TOWN OF WINCHESTER
PLANNING BOARD MEETING
TUESDAY, FEBRUARY 11, 2020 @7:30PM
SELECT BOARD ROOM

OFF HIGHLAND AVE/ABBY ROAD SUBDIVISION

TO: Winchester Planning Board
FROM: Beth Rudolph, PE, Town Engineer *BER*
DATE: February 6, 2020
RE: Abby Road Subdivision – Request for Release of Lots

Attachment 1

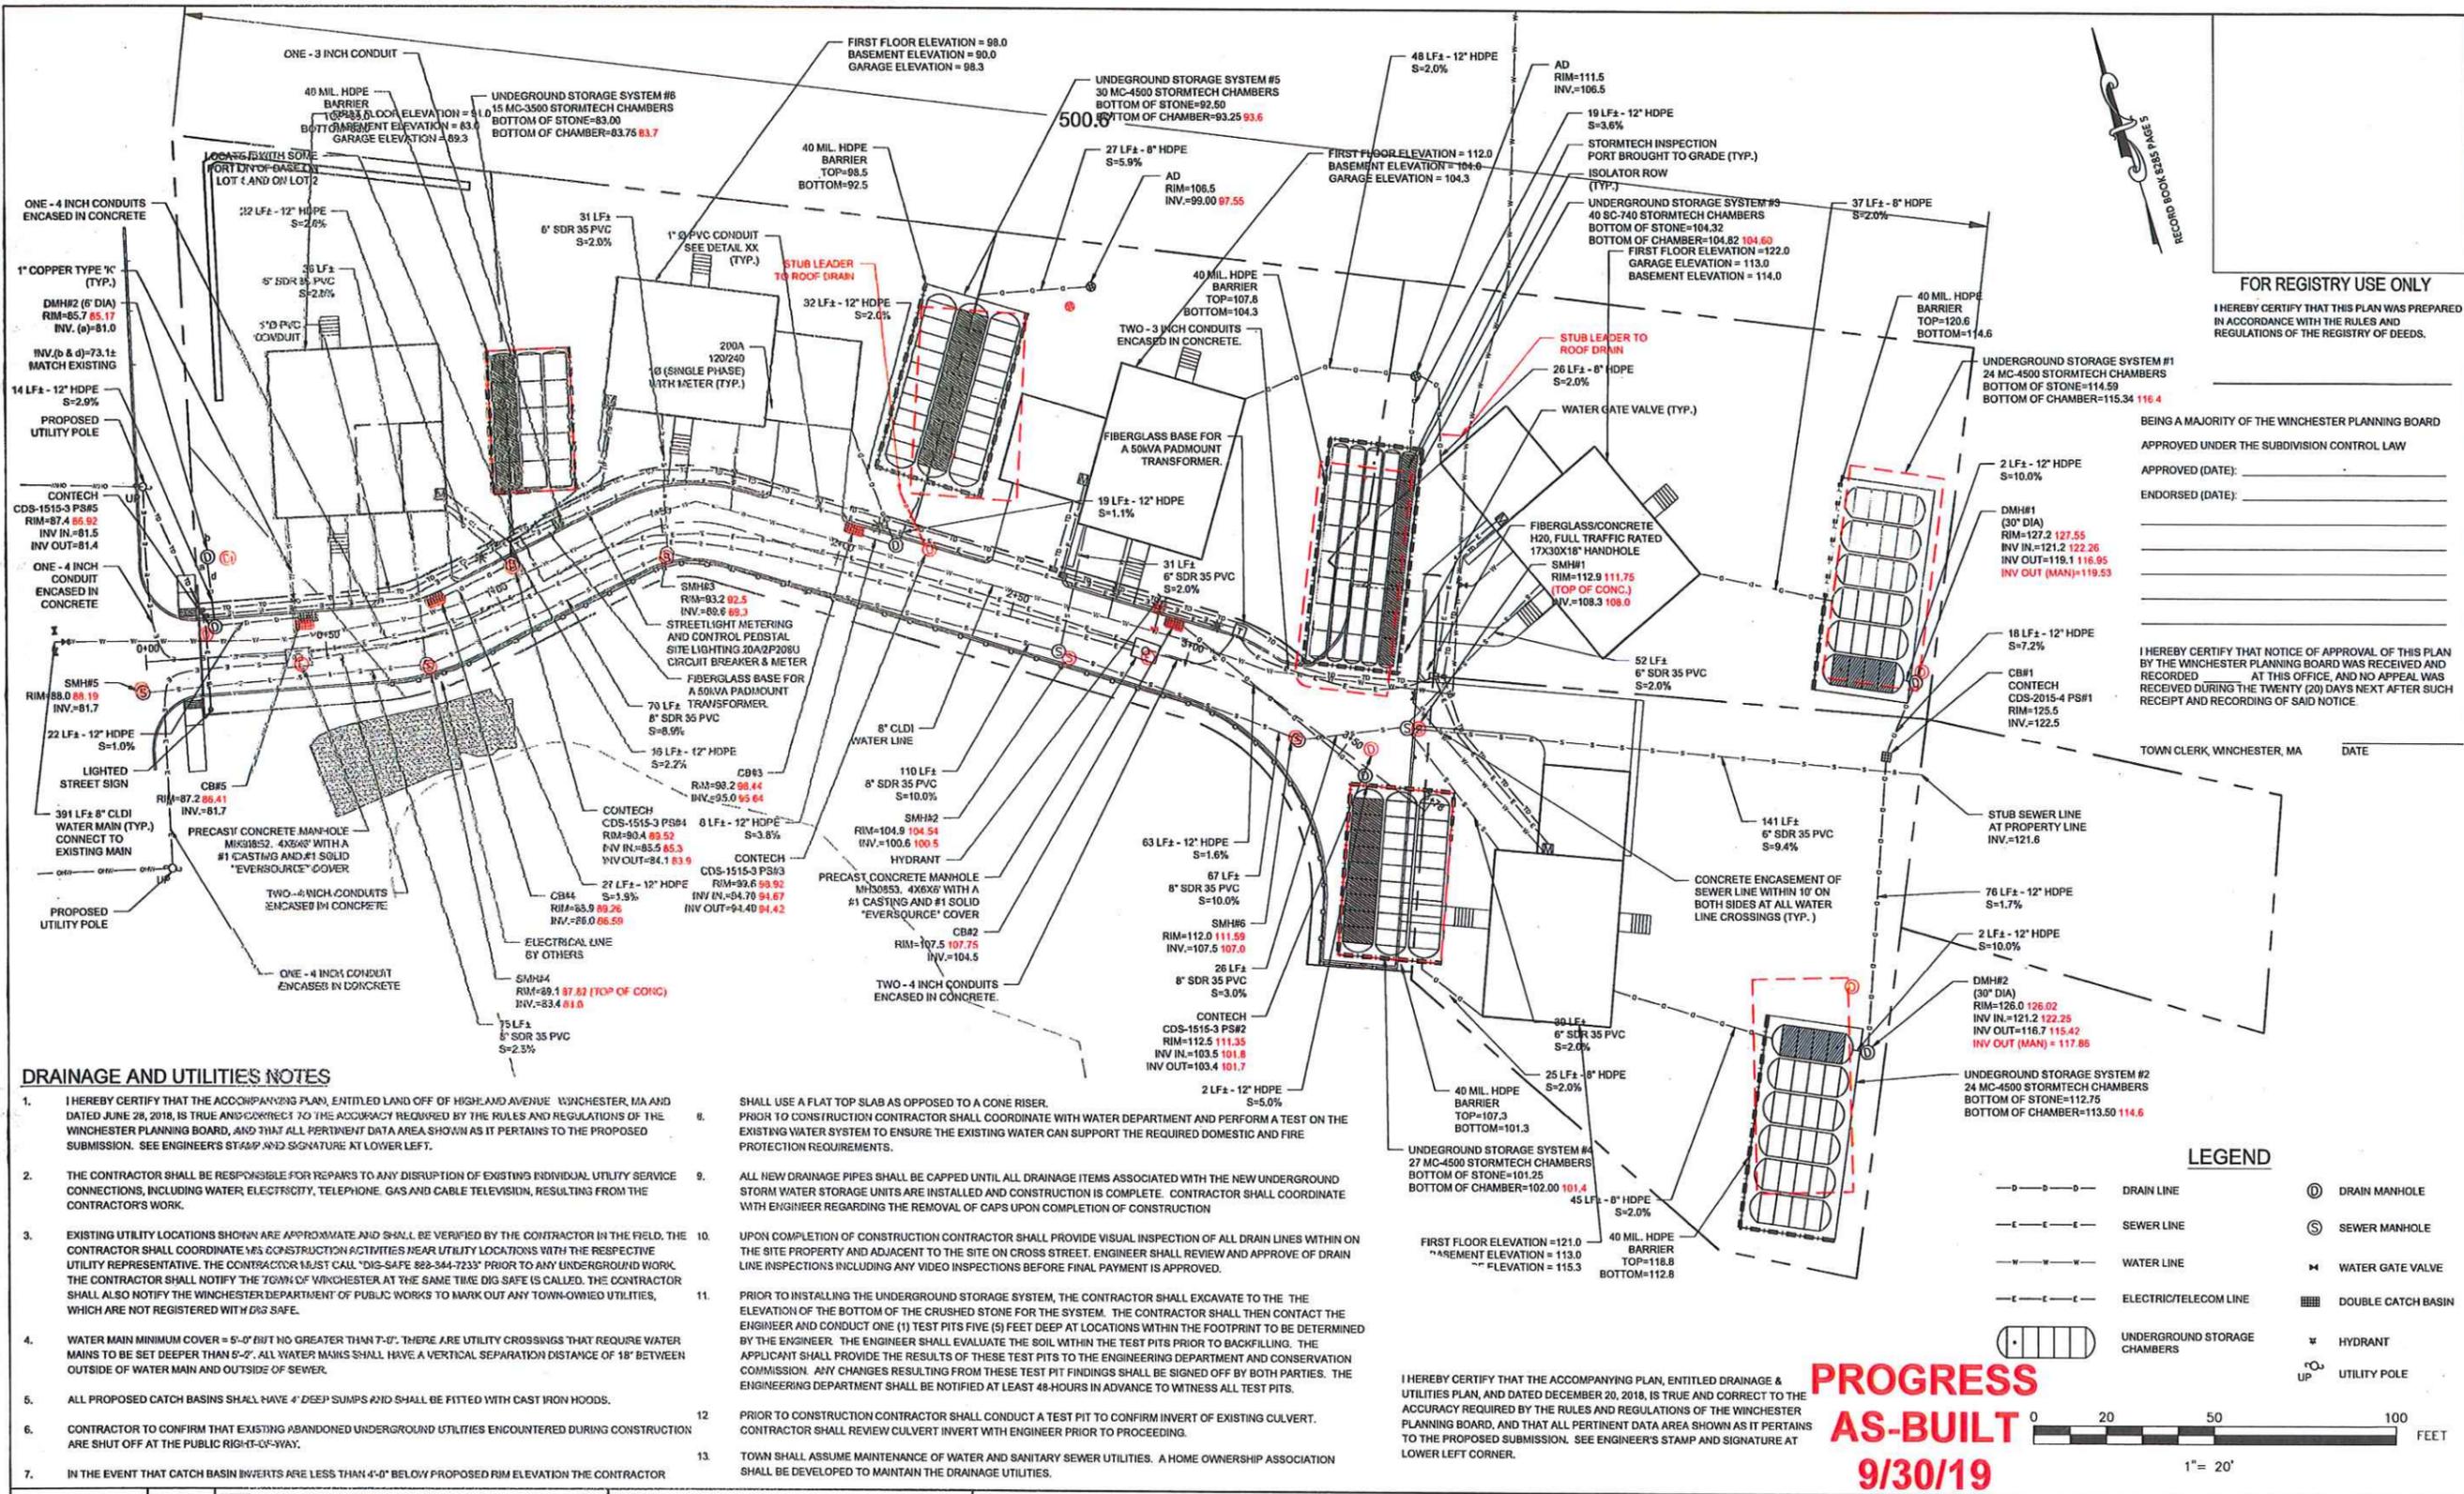
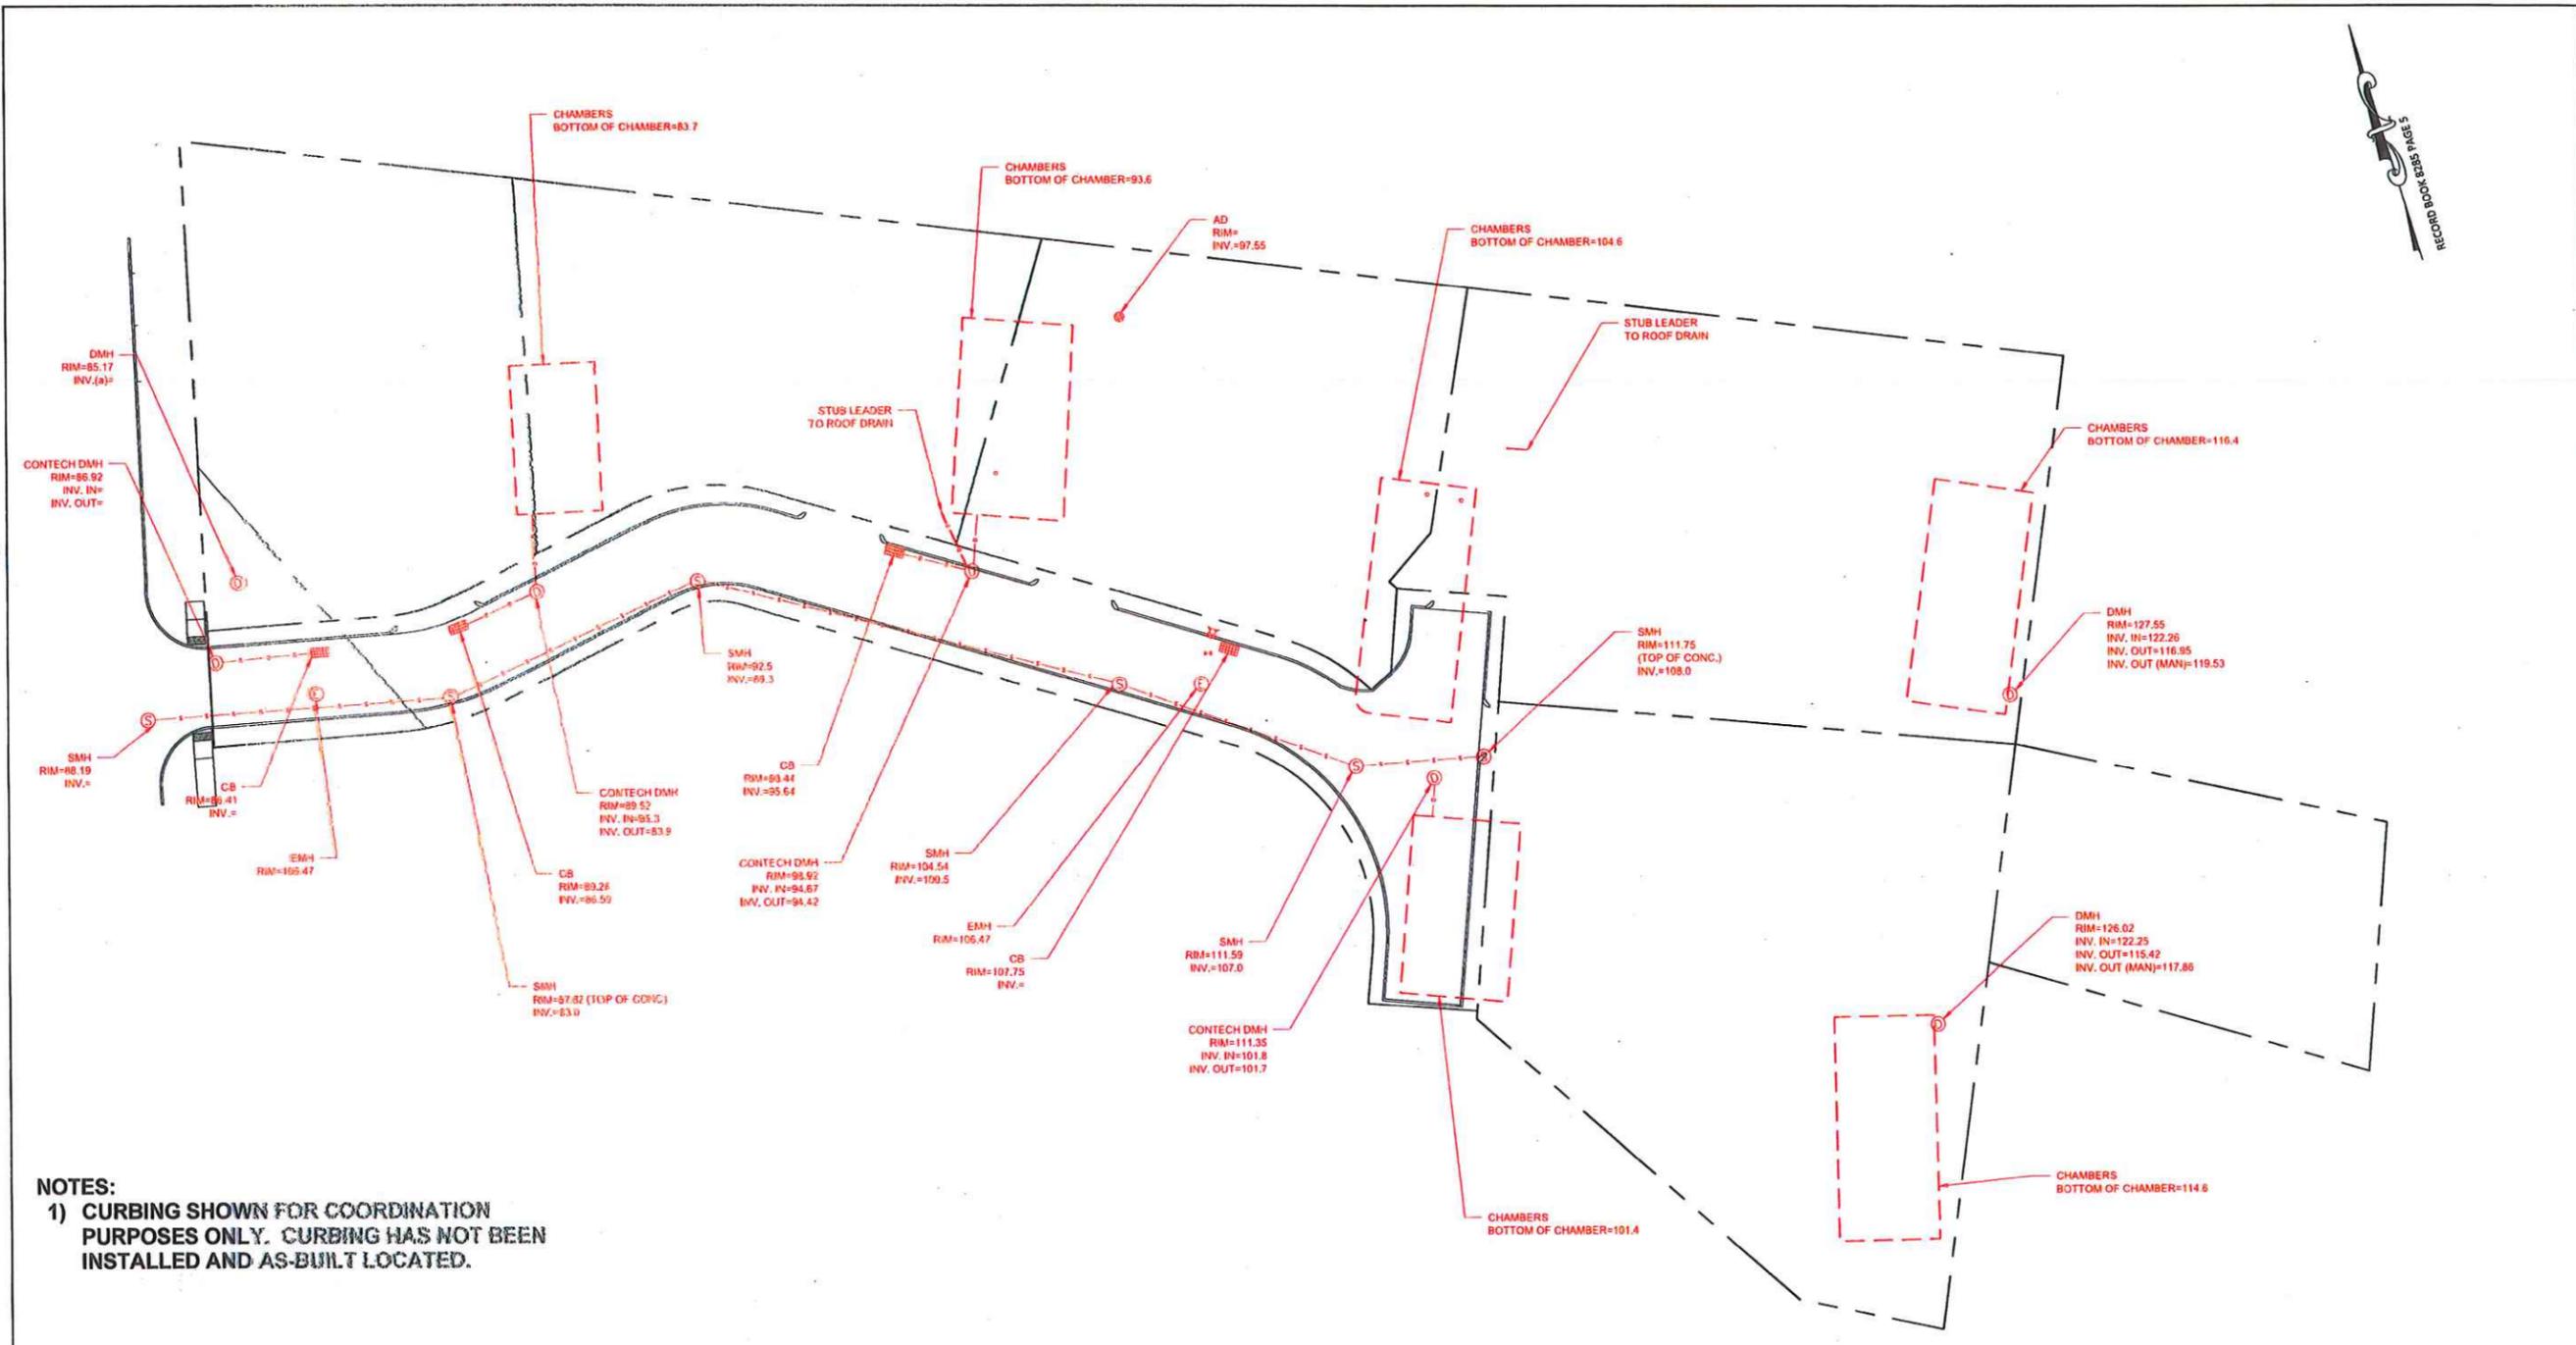
- (5) Interim As-built Plans – Prior to the release of the lots, the applicant should be required to provide an updated interim as-built plan for the project in accordance with the requirements of Section 7.21 of the Subdivision Regulations. The plans must be stamped by a Professional Land Surveyor and Professional Engineer, and include the certifications outlined in Section 7.21.2 of the Subdivision Regulations. Previous interim as-built plans were received on September 30 and November 11, 2019 (Attachment 1), but were not stamped nor did they include this certification.
